### ADDENDUM NO. 1

To the Drawings and Project Manual dated 16 June 2017

**TAS/ADA FIRE MARSHAL  
DEFERRED MAINTENANCE PROJECTS  
MIDWESTERN STATE  
UNIVERSITY**

Addendum Date: 2 August 2017

**BOLIN SCIENCE HALL - FIRST FLOOR - AREA 1C**  
**ELECTRICAL PLAN**

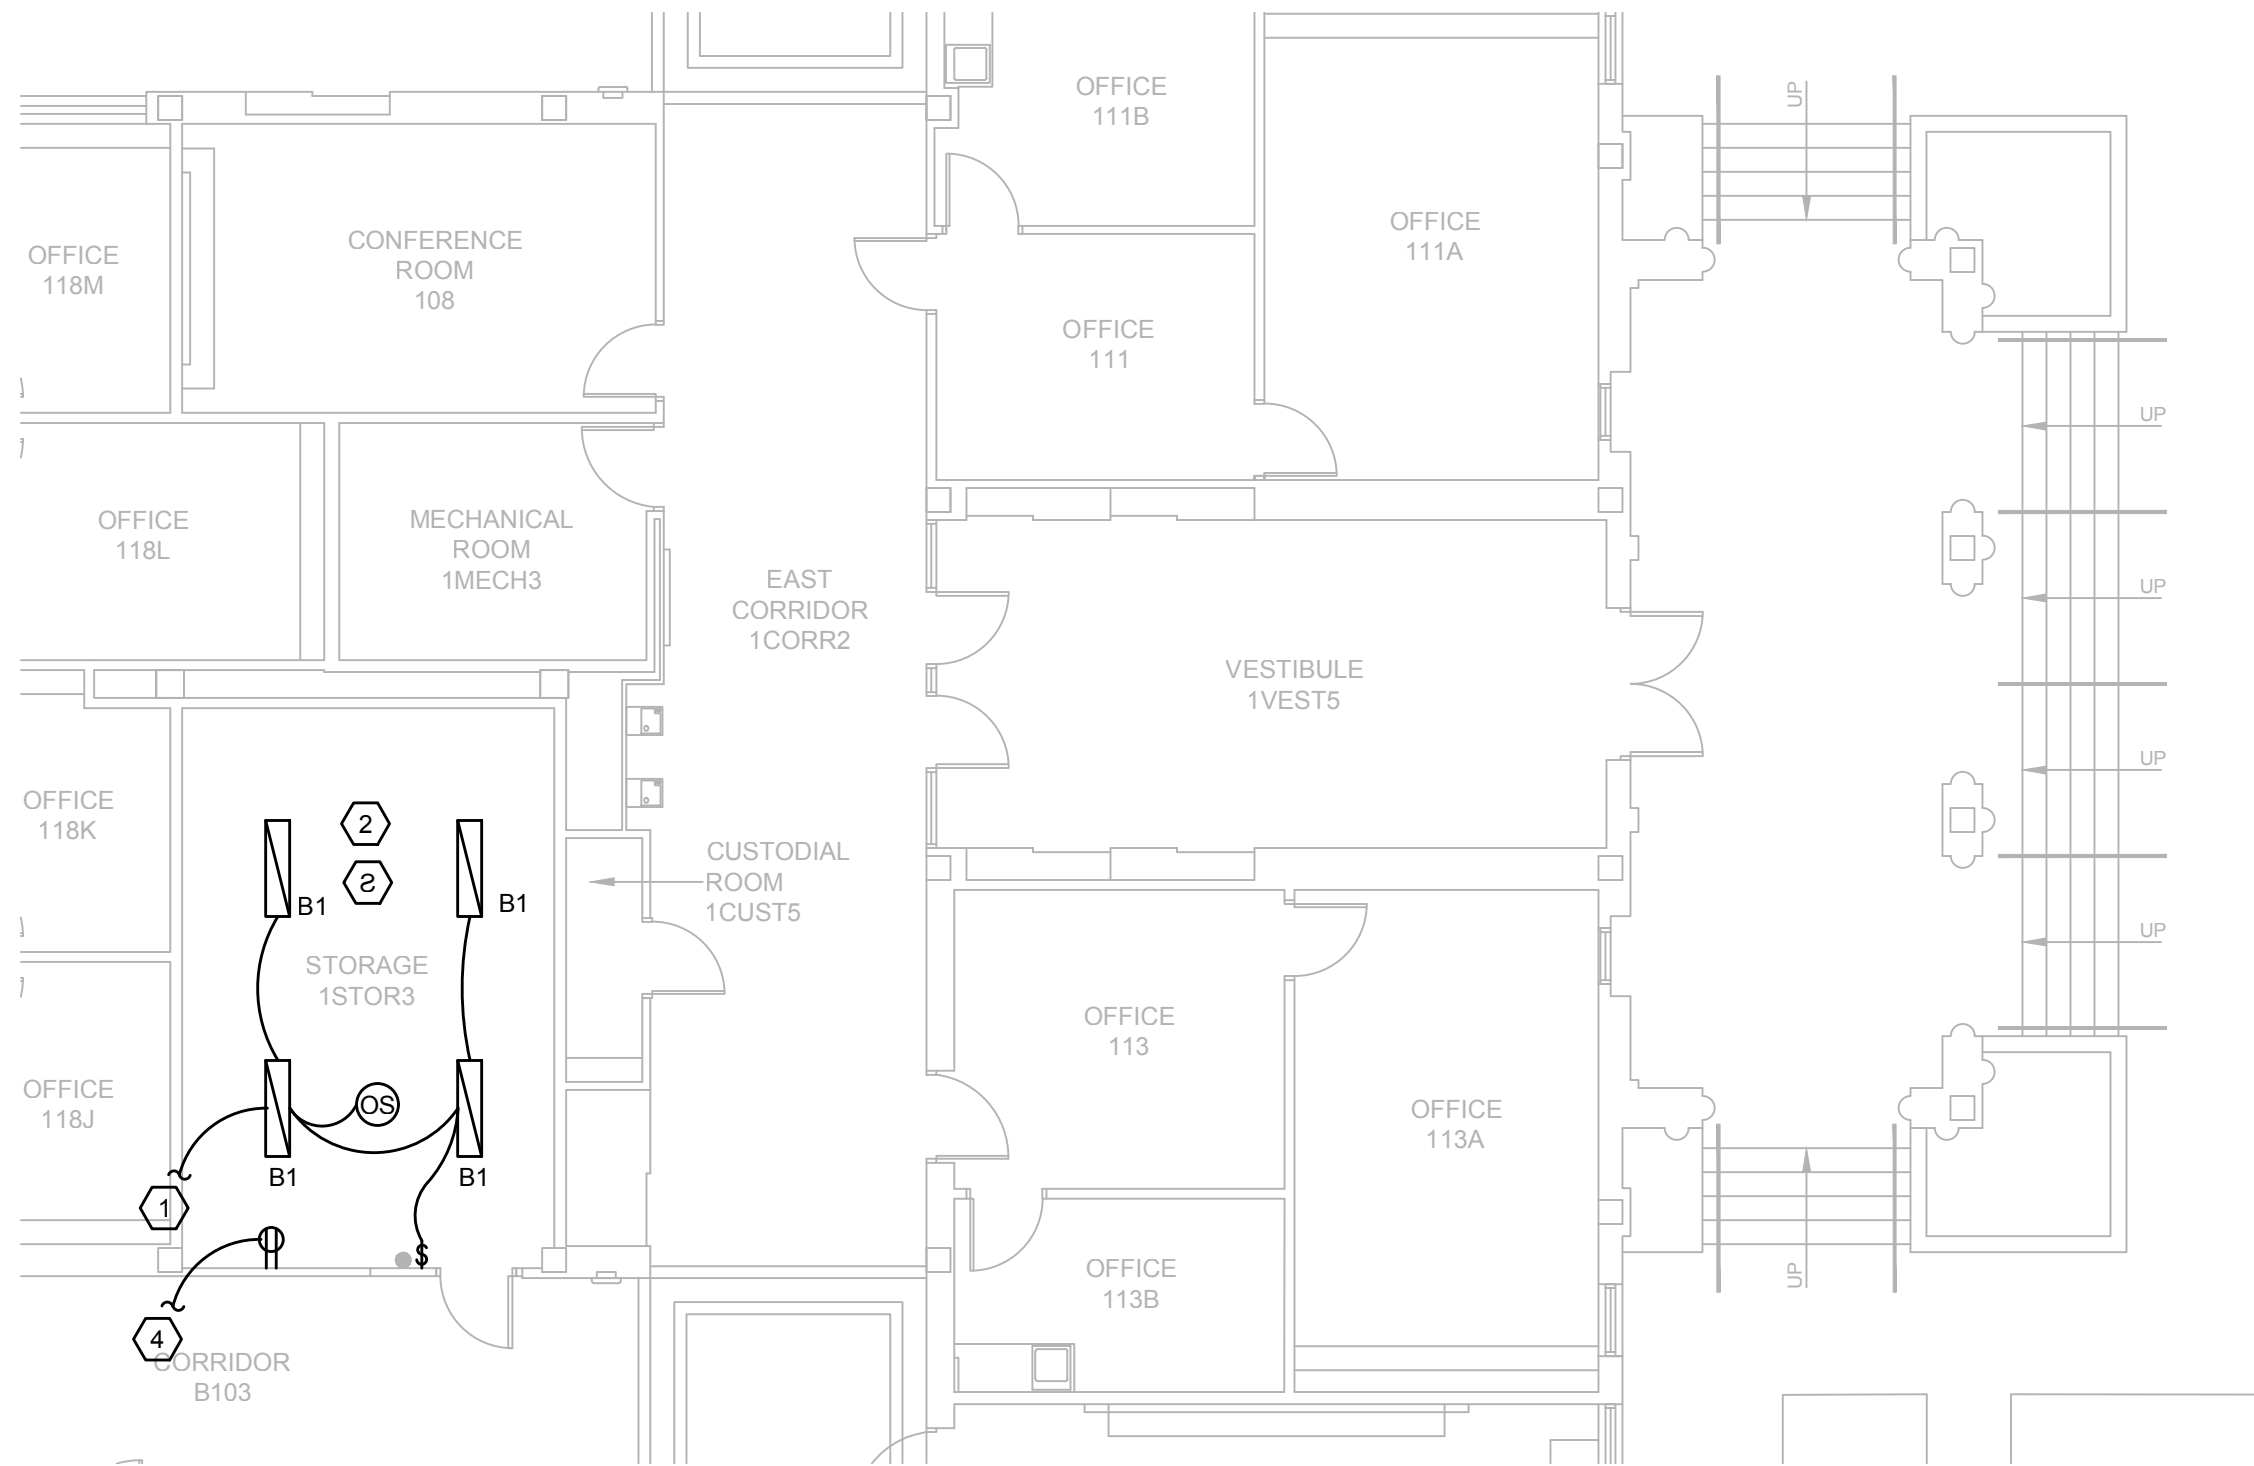
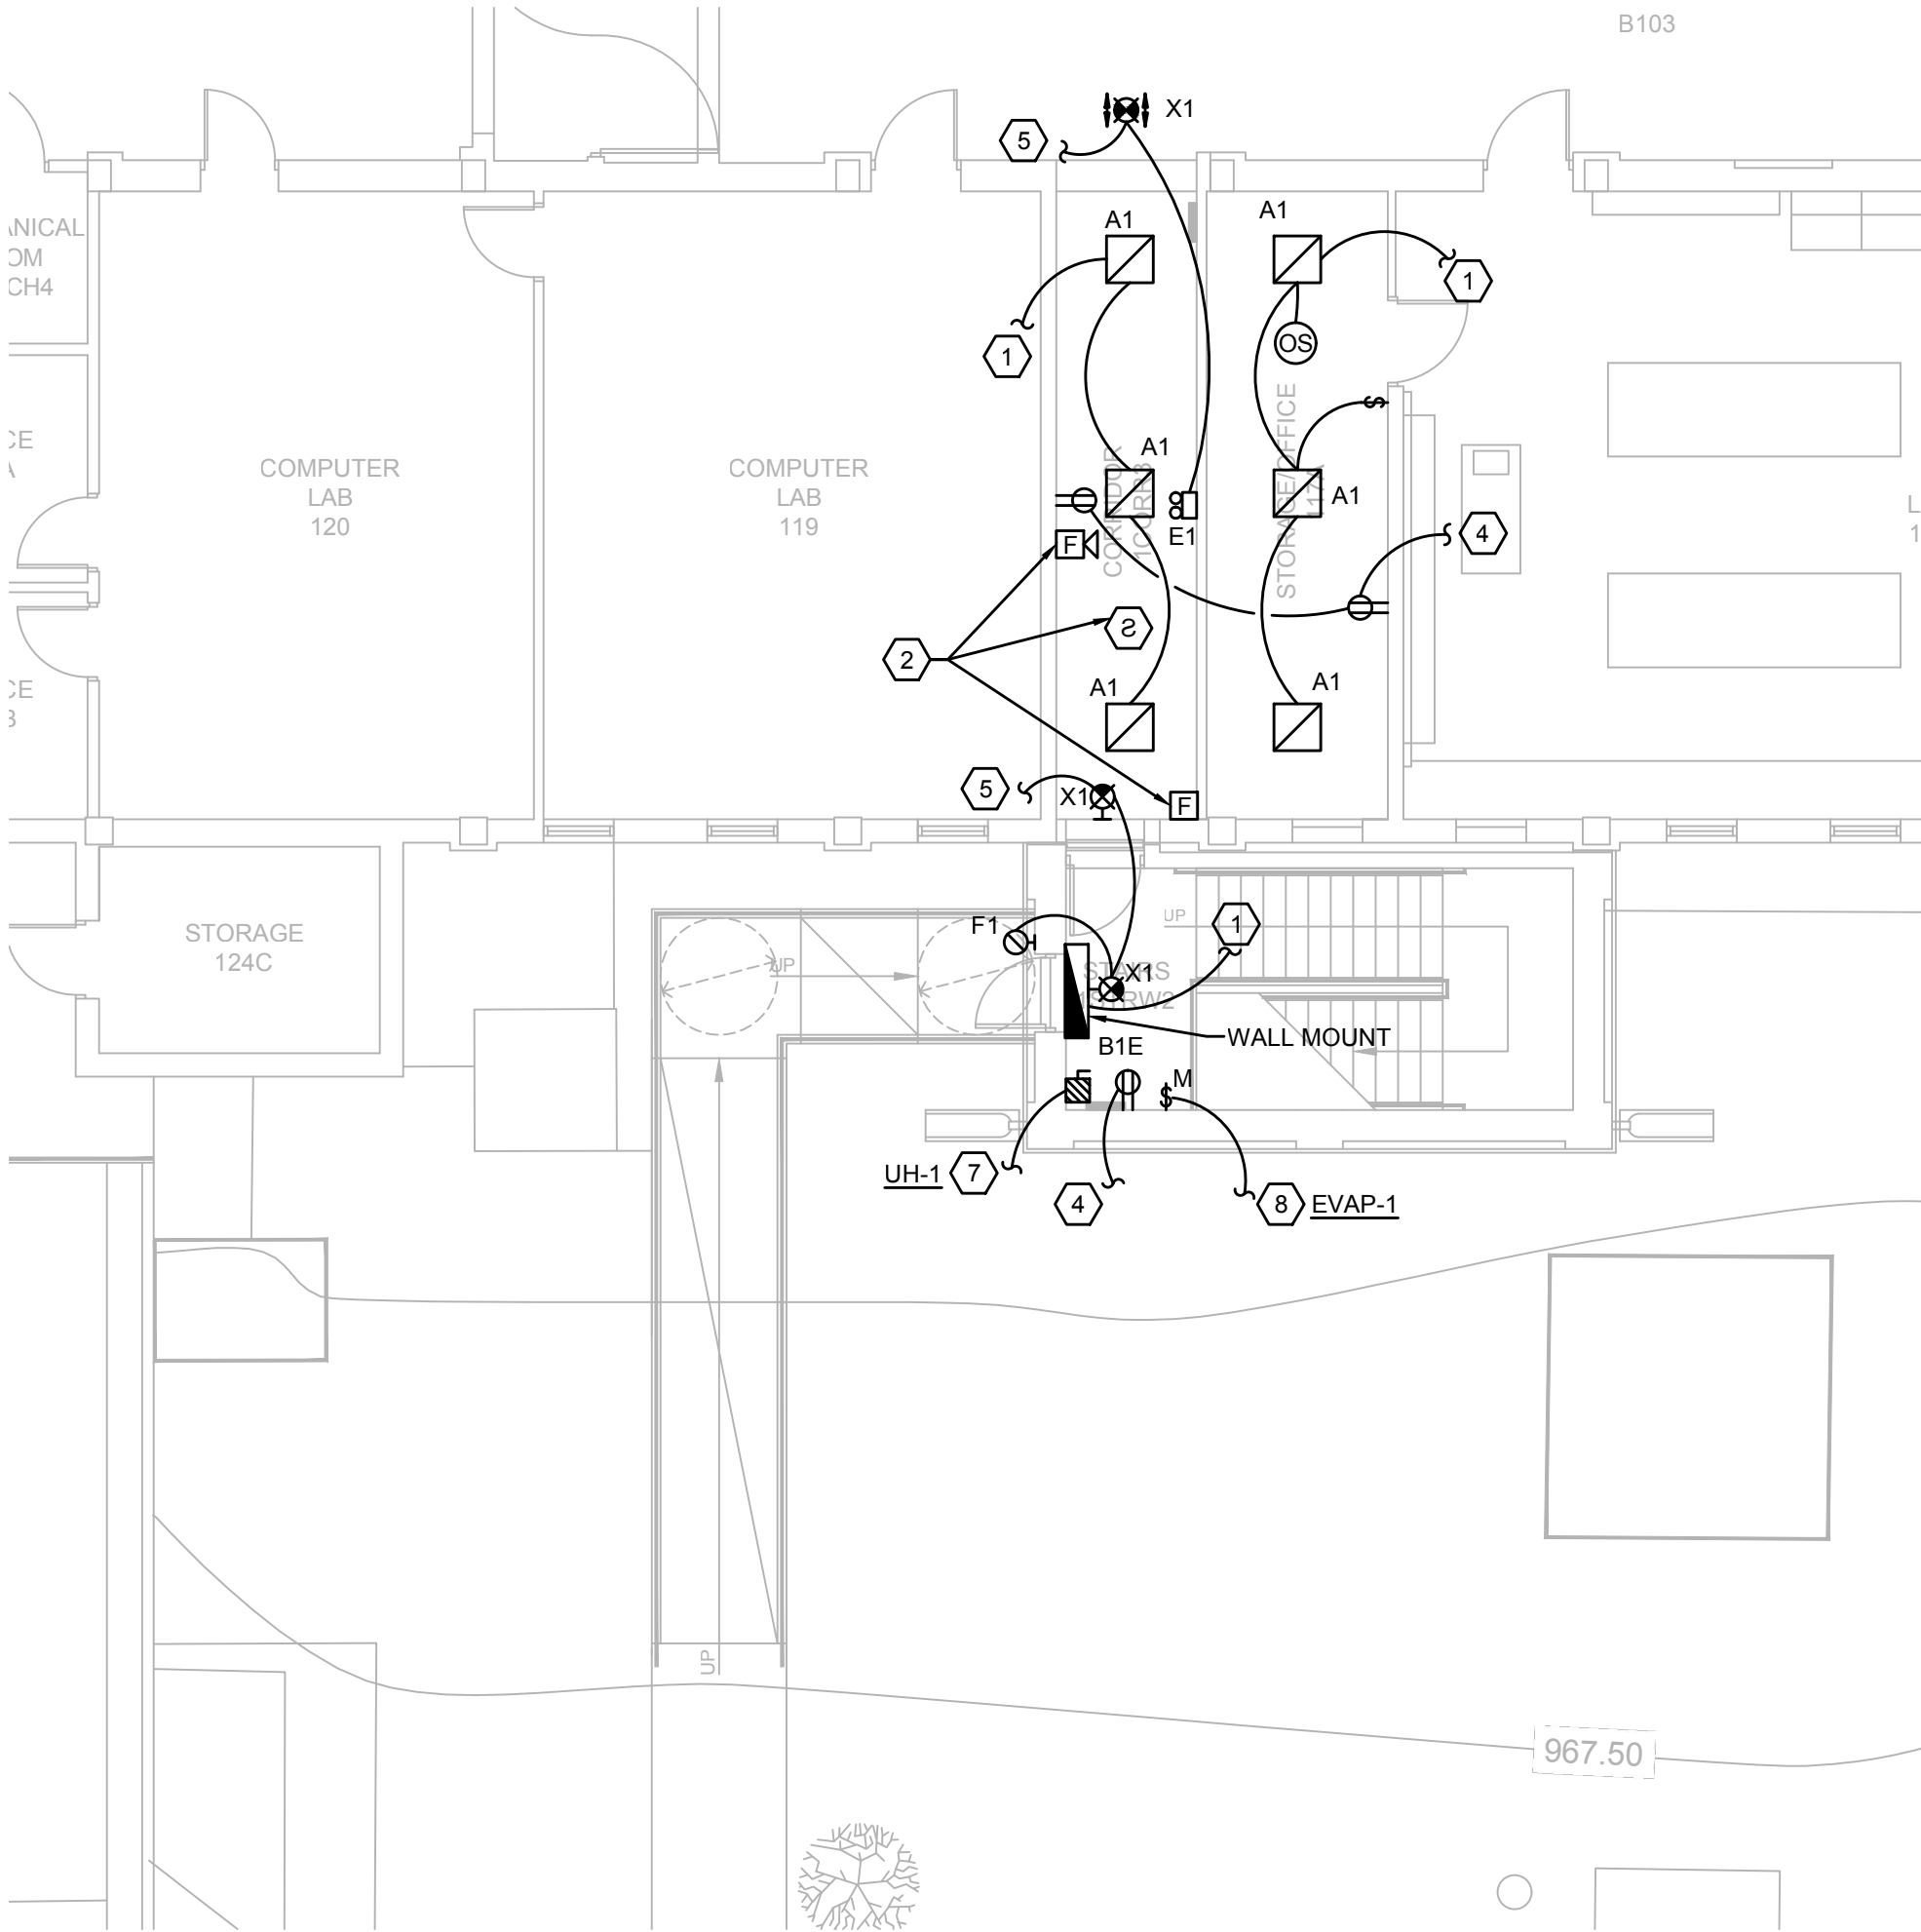
2. Sheet B-E101 – Revised Drawing as follows:
  - a. Modify Key Note #11 to indicate circuit homerun for heat trace and provision of GFP device.
  - b. Modify Key Note #15 to clarify quantity of conduits.
